Case Number: 306102; 512 no. apartments. Former Techrete Site, Beshoff Motors, Garden Centre, Howth Road, Howth, Dublin 13.

1.0 Introduction

2.0 Cycle Facilities Along Howth Road

Annotated extract of the National Cycle Manual (page 19)

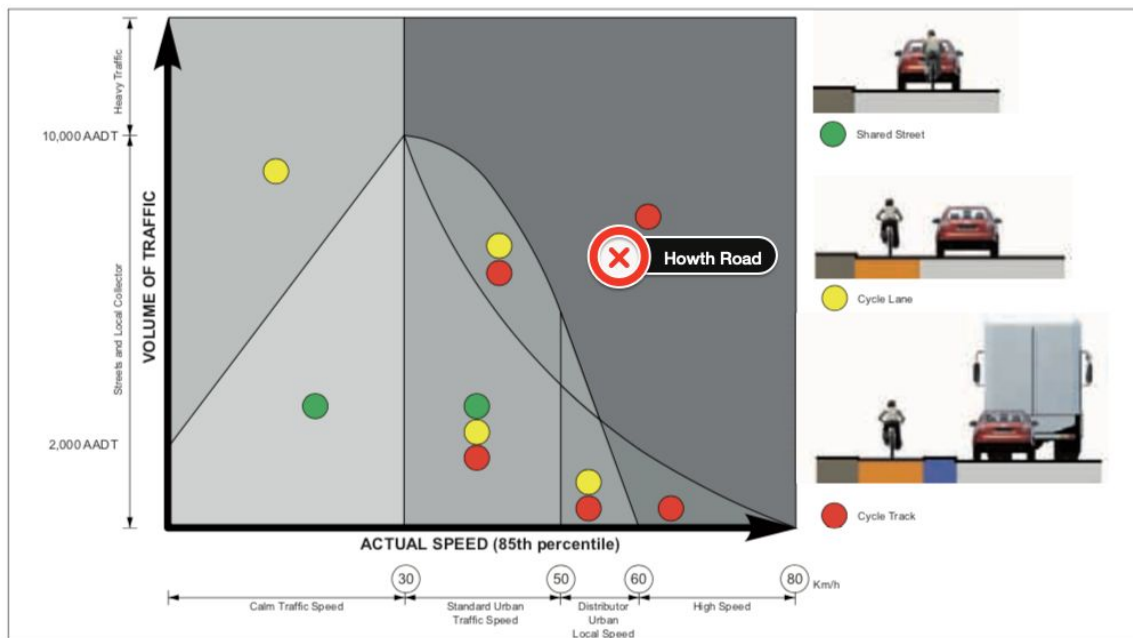
Howth Road has a speed limit of 60km/h, so it is safe to assume that 85th percentile speeds on the Howth Road are above 50km/h. The submitted *Traffic and Transportation Assessment* shows that existing traffic levels on the Howth Road are in the range of 7,500-8,000 AADT. According to section 1.7.4 of the NTA's *National Cycle Manual* the necessary level of segregation needed to enable and encourage people to cycle safely and comfortably is a curb separated cycle track.

The proposed redesigned Howth Road does not include any dedicated cycle facilities (engineering drawings 'Proposed Road Layout').

We ask the planning authority to attach a condition that alters the proposed redesign of Howth Road to include the cycle facilities needed to deliver secondary route 1A of the GDA Cycle Network Plan within the NTA's National Cycle Manual guidance. This will in turn accomplish the objectives of the GDA Transport Strategy and the Fingal County Council Development Plan.

Figure 4.42: Illustration of the benefits of reduced corner radii on pedestrian and cyclist safety (images based on Figures 6.3 and 6.15 of the UK Manual for Streets (2007)).

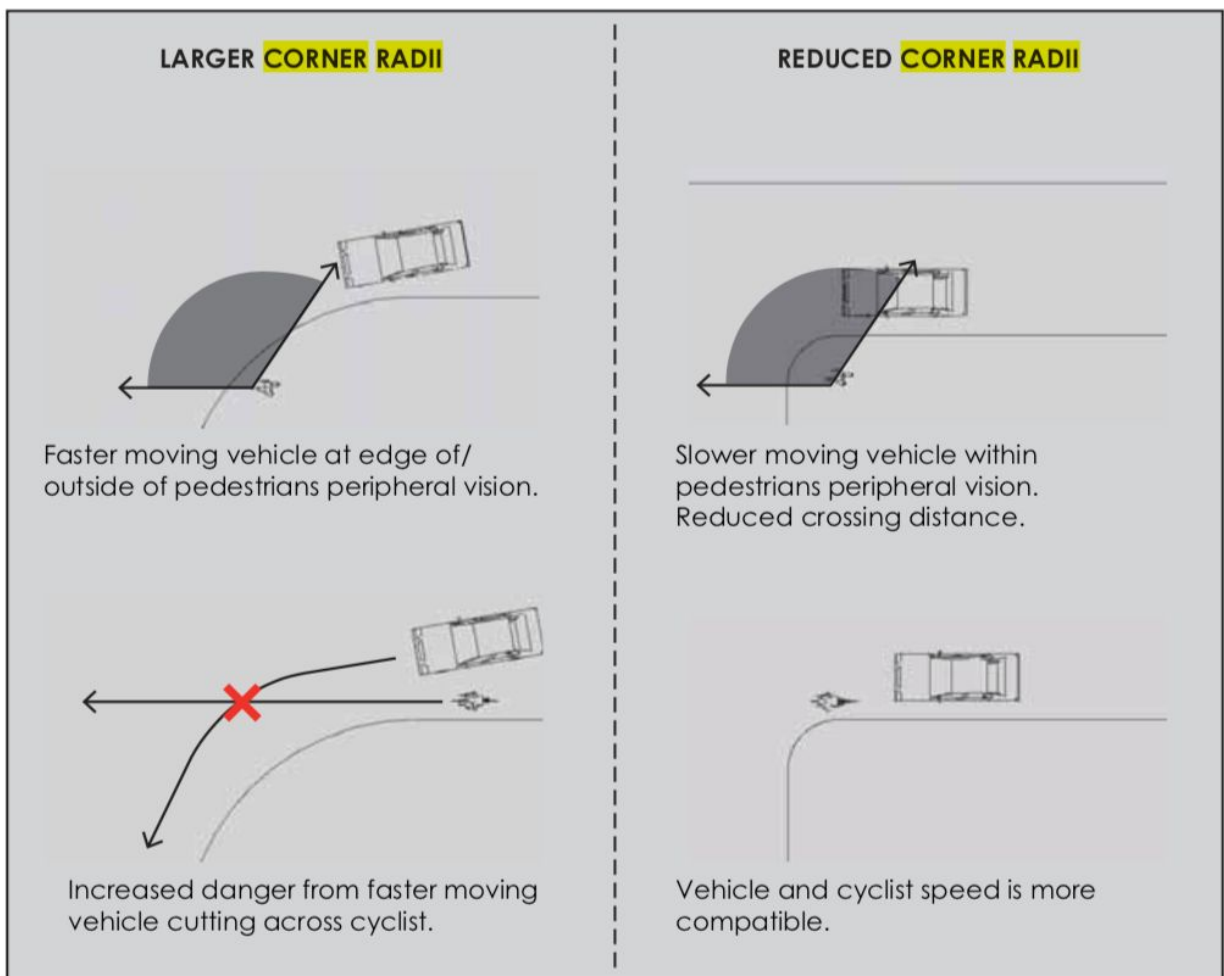
The engineering drawings 'Proposed Road Layout' show that the corner radii on the two proposed entrances are 6.5m. Section 4.3.3 of DMURS states:

In general, on junctions between Arterial and/or Link streets a maximum corner radii of 6m should be applied.

The proposed 6.5m corner radii are overly large for the entrance to an underground car park. This is particularly true for the entrance to Block A, which has 6.5m corner radii, but no loading area and extremely infrequent use by heavy vehicles.

If the planning authority deems to grant permission we request that a condition be attached to reduce the size of the two underground car park entrances in order to reduce the traffic hazard for people walking and cycling.
